LOCAL PLANNING PANEL – THE HILLS SHIRE COUNCIL DETERMINATION OF THE LOCAL PLANNING PANEL ON 15 MAY 2024

ITEM 1: LOCAL PLANNING PANEL - PLANNING PROPOSAL – MELIA COURT AND GLEN ROAD, CASTLE HILL (5/2024/PLP)

PURPOSE

Figure 9
800m Walkability Catchments from Nearby Metro Stations
(Subject sites outlined in red, 800m walkability catchments shown as dashed blue line)

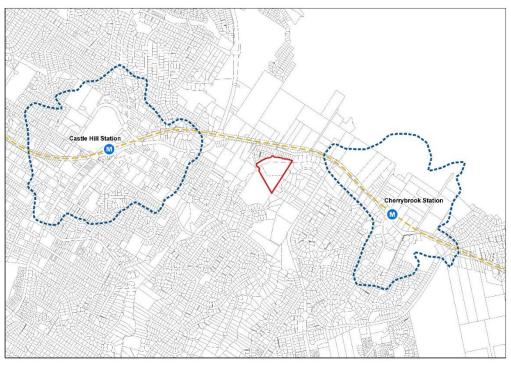
The Proponent's material identifies the subject site as being within 800m – 1000m walking distance of a Metro Station, however this is not the case. The subject site is located well outside the 800m walking catchment and is around 1.5km walking distance from Cherrybrook Metro Station and 1.7km walking distance from Castle Hill Metro Station. This is nearly a 20 minute walk that is exacerbated by steep topography and limited connectivity at this distance from the station. The feedback received from Transport for NSW as part of the scoping process identified that the site is *not* within an easy walking distance (e.g. 800m walking catchment) of a Metro Station.

The planning proposal does not align with objectives for supply of housing in the right locations. Furthermore, it would not even meet the criteria for the recently exhibited Government reforms relating to diverse and well located housing (noting its distance from a transport hub or Metro stations extends beyond this). The proposal does not respond to any new infrastructure, changing circumstances or changing population or demographic trends. The supply of housing in this location at the density and built form proposed, is not warranted, noting the areas already identified as suitable for residential uplift in proximity to centres and transport infrastructure and the prevailing environmental issues at the subject location.

Figure 13 High Level Flood Affectations

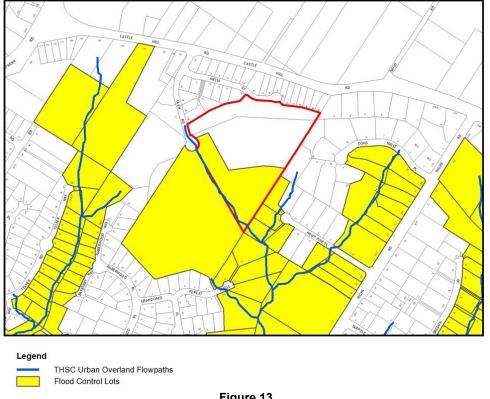
The Flood Impact and Risk Assessment indicates that several drainage easements run through the northern part of the site from Melia Court and a water supply easement runs through the middle of the site. It identifies that flooding is limited to within the drainage gully to the west of the site and that the site is marginally affected by local overland flow from Glen Road and the upstream Melia Court. It is indicated that the proposed development generally complies with the Ministerial Direction. Council officers have not been able to confirm the veracity of the flood modelling outcome at this stage and should the proposal proceed to Gateway Determination a revised report would be required that provides further details of the modelling for further assessment of the site and the engineering response in its entirety.

Based on the information submitted, Council officers are not yet satisfied that potential flood risks have been overcome or that the associated stormwater management strategy is satisfactory. This may be able to be resolved subject to additional work by the Proponent,

Figure 15
Indicative Built Form Outcomes
(Source: Proponent's Urban Design Report, DKO)

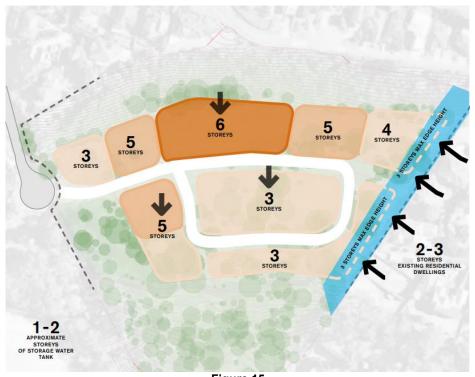
The planning proposal seeks to apply maximum height of building controls to the subject land, varying between 10m and 22m to facilitate a built form outcome ranging from three to six storeys (as shown in Figure 15). The proposed height of buildings is inconsistent with the character and objectives for development within the locality, noting the low density residential and environmentally sensitive nature of the area.

Figure 16
Sensitive Biodiversity Values Map

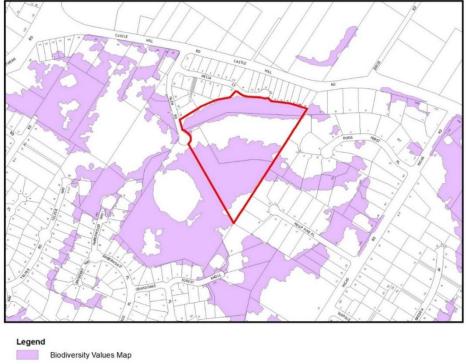
The Proponent has submitted a Biodiversity Development Assessment Report (BDAR) prepared by Fraser Ecological Consulting (dated 6 February 2024 and provided as Attachment 12). The BDAR identifies that approximately 2.5Ha of Blue Gum High Forest is present on the site, primarily on the southern portion. It indicates that the vegetation along the northern boundary does not constitute Blue Gum High Forest and is dominated by weeds and the central part of the site contains introduced grasses and weeds. Two threatened species of fauna, the Powerful Owl and Grey-Headed Flying-Fox, were detected (vocalisations) during surveys of the subject land. It also noted that while the Dural Land Snail was not detected on site, it has been previously recorded in the locality and as such, it is assumed that there it is present as a precautionary measure.

The BDAR identifies that Blue Gum High Forest is an entity that is at risk of serious and irreversible impacts and has identified some mitigation measures. However, the location and design of the proposed development has not been adequately informed by the biodiversity values. Further, the extent of earthworks and the asset protection zone has not been accurately considered as part of the assessment. Therefore, the development as proposed is considered highly likely to result in serious and irreversible impacts to the Blue Gum High

Tree Survey (Source: Arboricultural Impact Assessment Report, H20 Consulting Group)

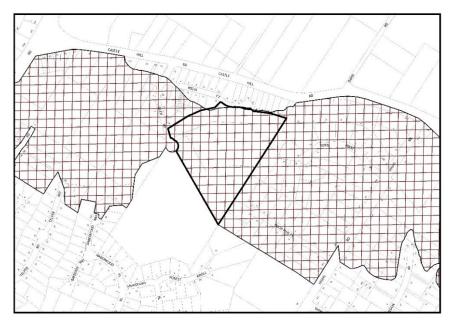
The Arboricultural Impact Assessment indicates that there are 187 trees located within the proposed building footprint that will require removal. This includes 66 ecologically significant Sydney Blue Gum trees, most of which (60) are of High Retention Value. A total of 63 High Retention Value Trees are located within the proposal footprint and will require removal to make way for construction works.

The Arboricultural Impact Assessment notes that the proposal is also expected to have a major encroachment into the TPZ of an additional 22 trees, including nine trees of High Retention Value (Sydney Blue Gum trees). Given the extensive excavation works that will be required to establish the underground carparks, and considerable amounts of overhead works to construct the buildings, none of these trees are expected to remain viable, thus have been recommended for removal.
